Attachment G. Technical Oversight Group Written Comments Restoration Alternatives

Feedback on Ridgefield Pits Technical Memo
Brice Crayne
Lower Columbia Fish Enhancement Group

Friends of the East Fork Comments to the Lower Columbia Estuary Partnership East Fork Technical Oversight Overview & Alternatives July 8, 2020 Memorandum
Oct. 04, 2020

Ridgefield Pits Restoration Project Memo to Technical Oversight Group

Draft Restoration Alternatives:

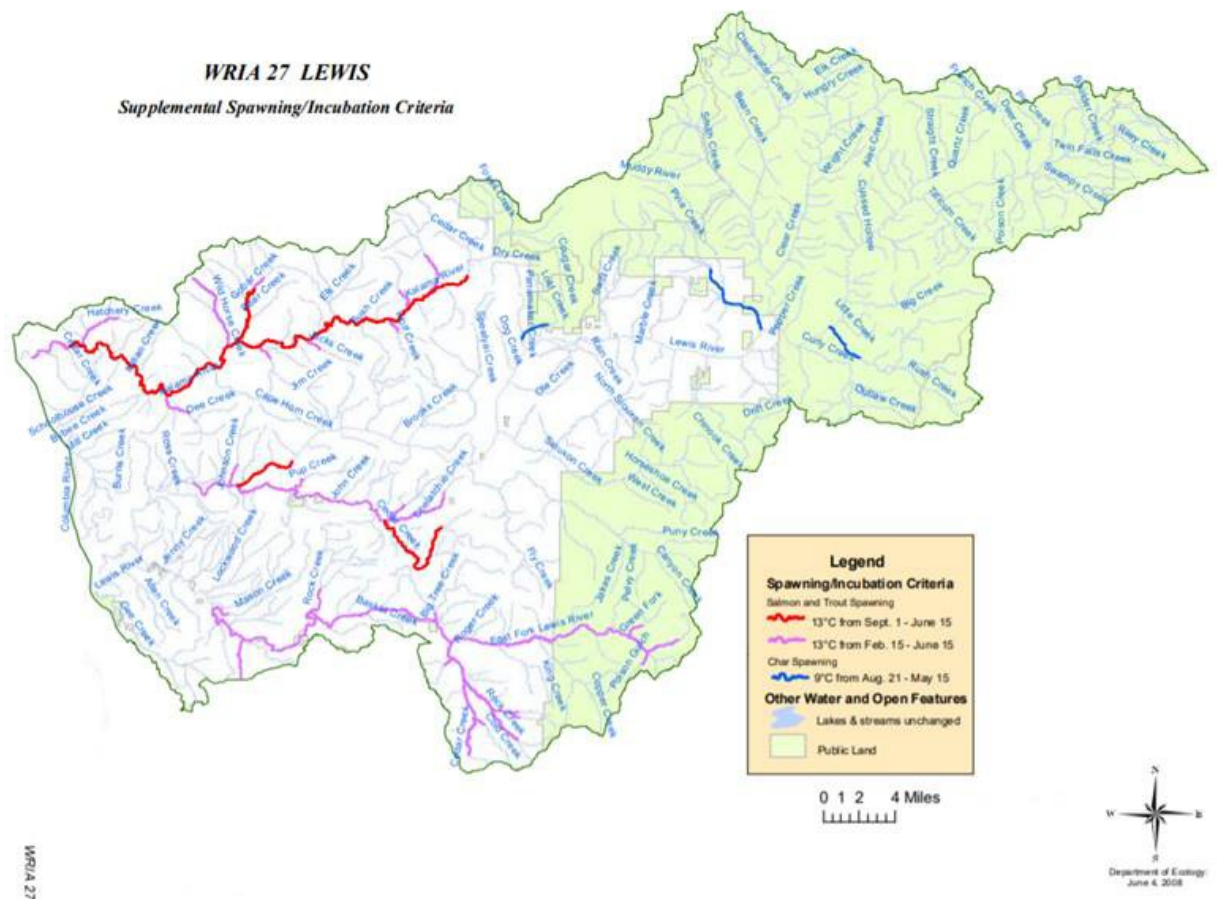
NMFS is most supportive of the Full Floodplain and Pits regrade, and believes this is the best option with respect to contributing to the recovery of the “Primary” ESA populations within the EFLR. It should be noted that NMFS is supportive of any habitat restoration actions, which support the recovery of ESA listed species and their critical habitats. However, we also understand that cost and other outside factors could influence the final restoration designs and future implementation of the Ridgefield Pits Restoration Project. Additionally, NMFS would be least supportive of the No Action/ Passive Recovery alternative, and would need significant evidence that the relocation of the main-channel alternative

would have a very low chance of failure (avulsing back into the pits), before supporting this alternative. Finally, NMFS thanks you for the opportunity to comment on the Ridgefield Pits Restoration Alternatives Memo, and looks forward to future collaboration with the Technical Oversight Group. We are standing by to assist with any pre-consultation requests with respect to ESA take coverage on proposed restoration activities. Please feel free to contact me (Joshua.ashline@noaa.gov) if you have any questions or concerns.
